## Concrete Supply Company – Mauldin Plant

### Unpermitted Industrial Stormwater Inspection SC

December 11, 2018

U.S. Environmental Protection Agency - Region 4

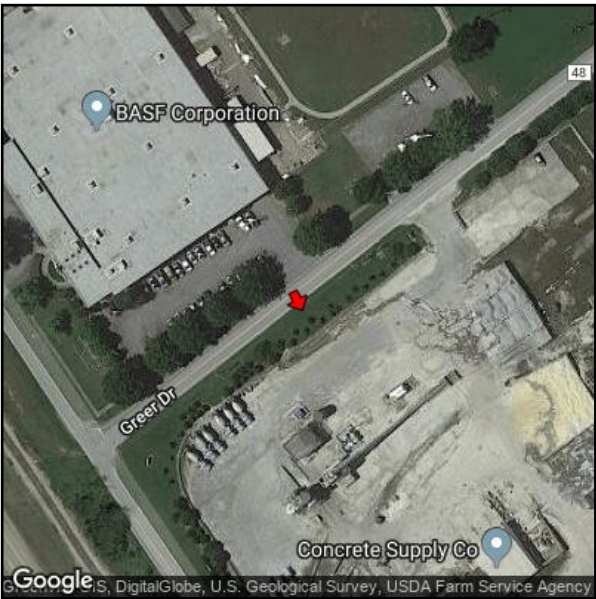
Attributes	
Description	Prior Outfall #1 is at base of wall in background. The facility stated that they have blocked the outfall and no longer treat it as an outfall. Evidence of ongoing drainage off-site at this location was visible from the NW side of the wall.

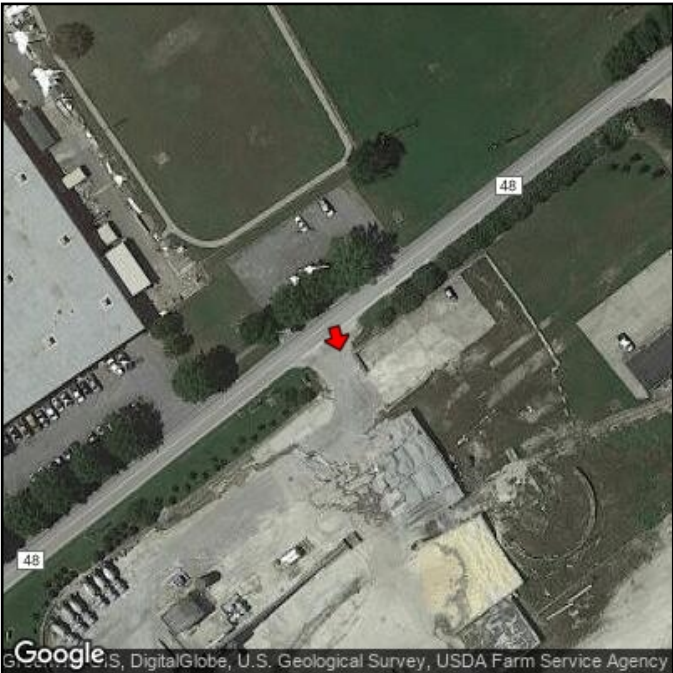
Attributes	
Description	Hand is pointing at location of Outfall #1. The facility stated that they have blocked the inlet to the outfall and no longer treat it as an outfall. Evidence of ongoing drainage off-site at this location was visible on the wet ground in the shadow.

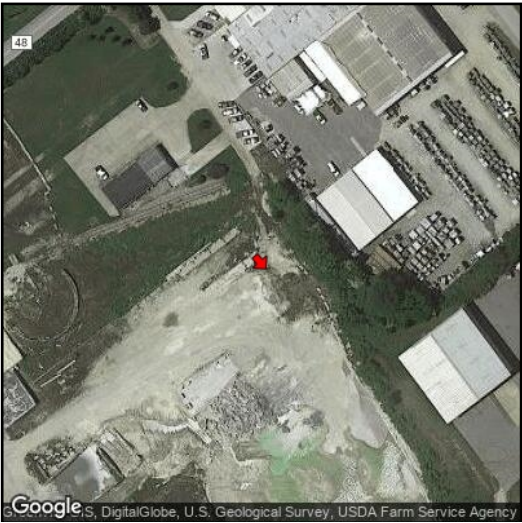
Attributes	
Description	View looking downgradient of water flowing towards Outfall #1 from the aggregate storage pile. The pile was being watered with city water.

**Feasibility Study**

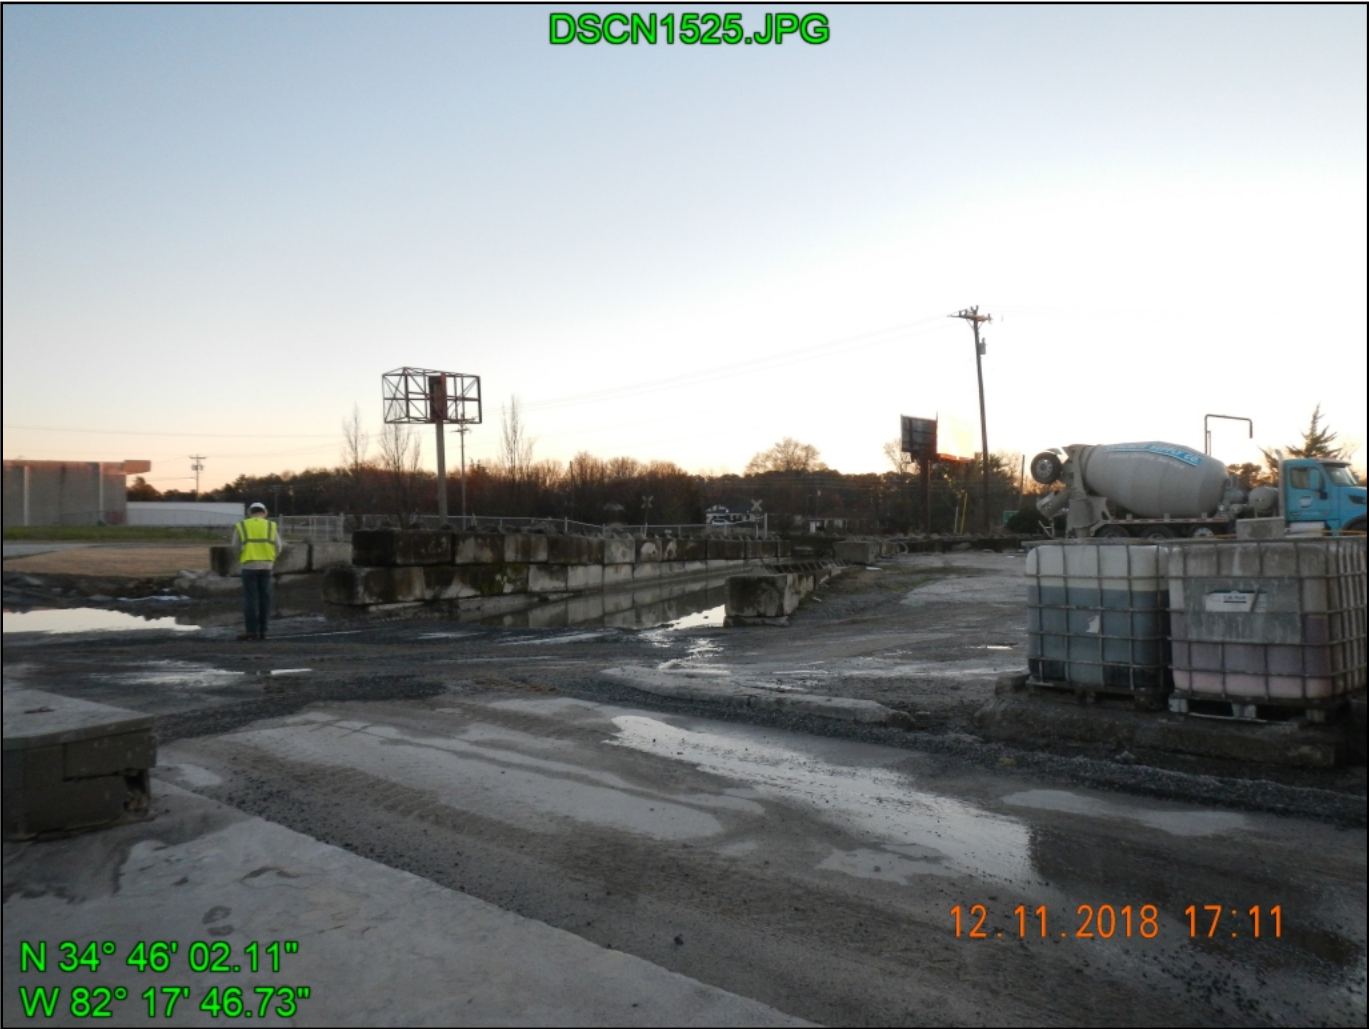
Attributes	
Description	The SWPPP contained a March 12, 2018 Feasibility Study statement. This "Feasibility Study" note contained no alternatives that were analyzed, nor any cost assessments.

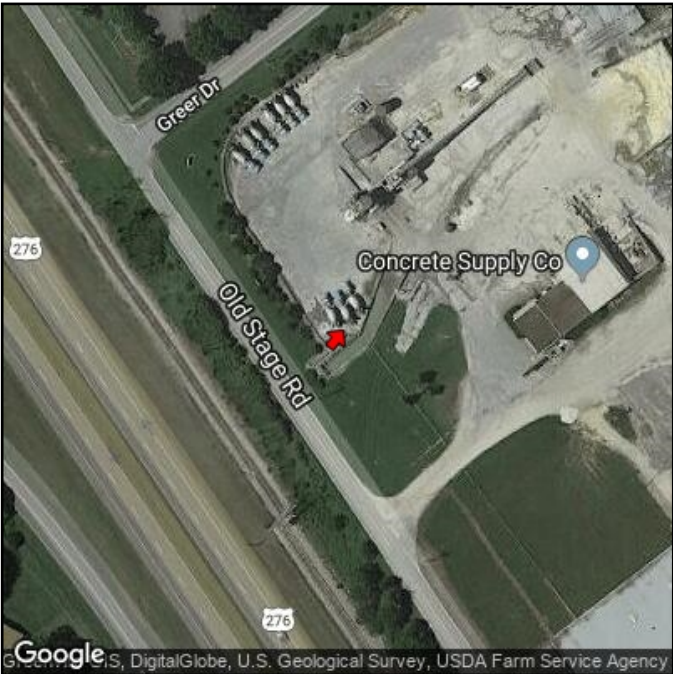
Attributes	
Description	Pump station in water recycling area. The holding basin had 3 inches of freeboard and evidence of past overflows.

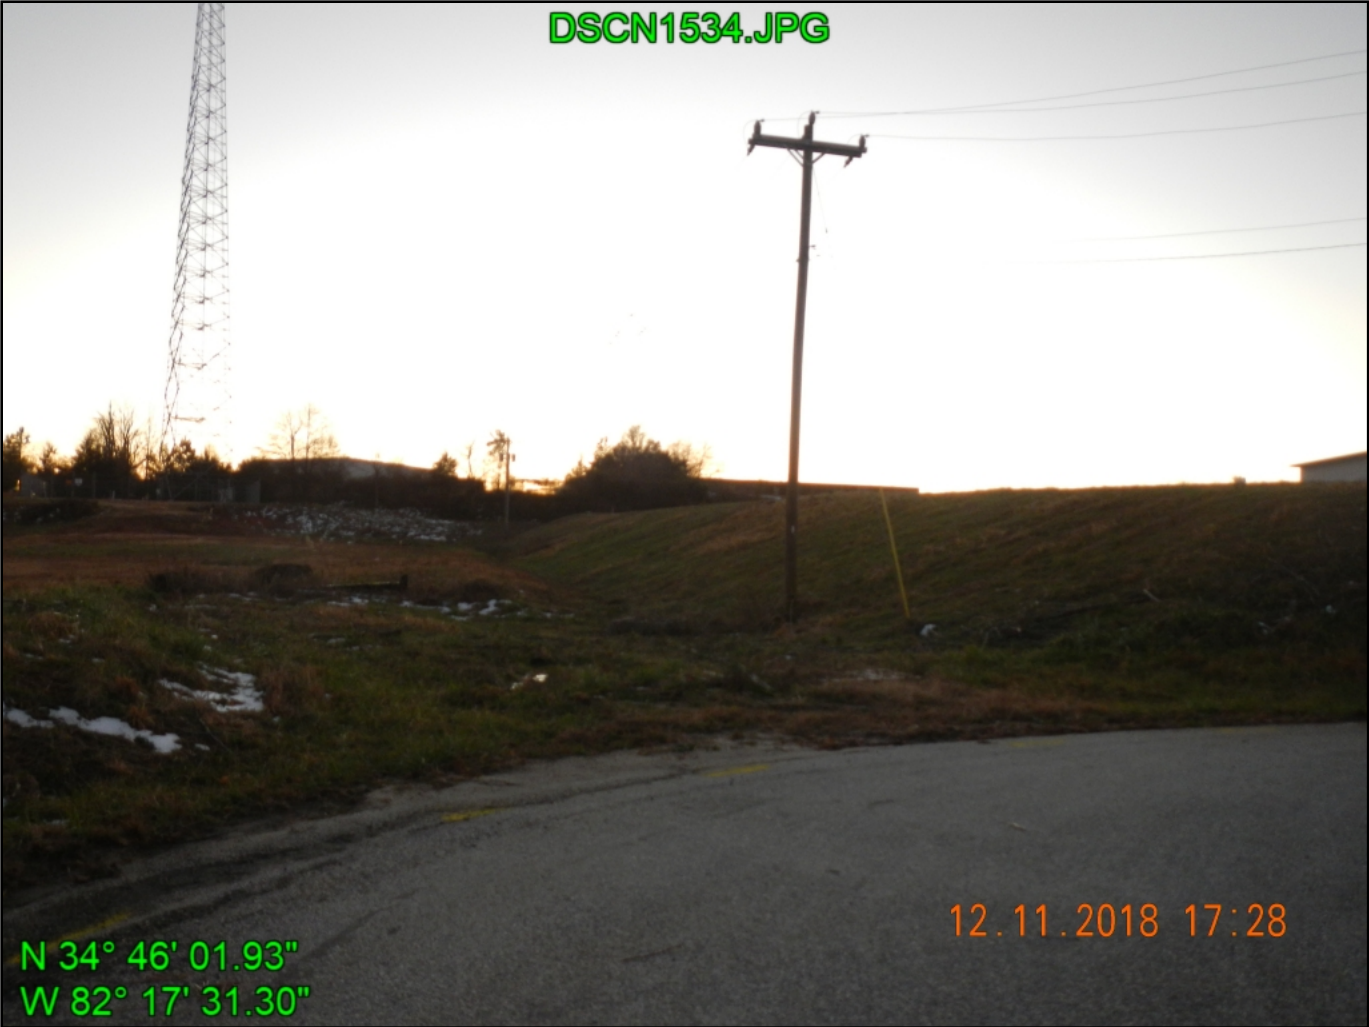
Attributes	
Description	Outlet side of the pipe under the road that handles runoff from this side of the site. This conveyance is next to the cell tower access road. Water was observed flowing through this conveyance.
